DATE: May 9, 2002
TO: Montgomery County Planning Board
VIA: Joe. R. Davis, Chief *JRD*
Development Review Division
FROM: Wynn E. Witthans *WW*
Planning Department Staff
(301) 495-4584

REVIEW TYPE: Project Plan Review
APPLYING FOR: Approval of 35 Single Family Detached Dwelling Units on 11.65 acres
PROJECT NAME: PARKSIDE
CASE #: 9-02001
REVIEW BASIS: Sec. 59-D-2, M. C. Zoning Ordinance

PROJECT PLAN # 9-02001

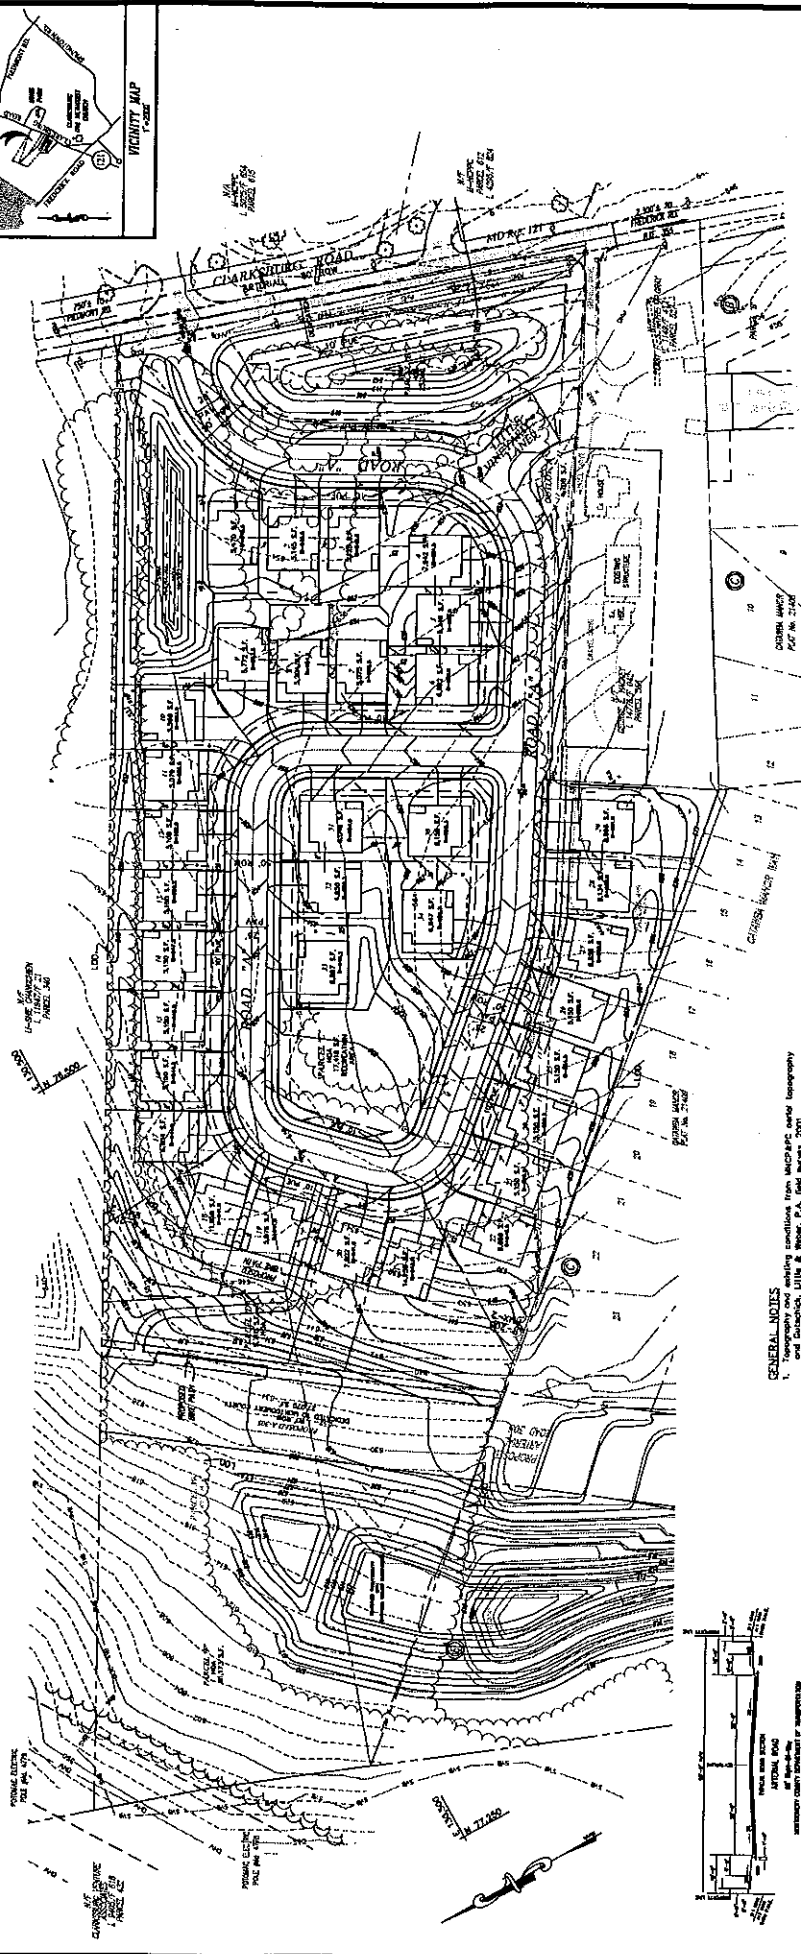
The proposed sidewalk and trail system achieves good connections to off site destinations. The proposed trail connects the community to the future bikeway along Mid County Arterial. Internal sidewalks lead down to the sidewalks. However, a small segment of additional sidewalk onsite is needed along the Little Vineyard Lane to eventually connect to the future community known as Cawtaba Manor. This additional sidewalk can be addressed at site plan.

The internal pedestrian circulation system shown on the site plan is adequate. Sidewalks (5-foot wide) proposed on both sides of all internal tertiary roadways and future street connections to adjoining properties as shown on the site plan are adequate.

Alignment of A-305 shown on the site plan is consistent with A-305 approved on the Catawba Manor subdivision.
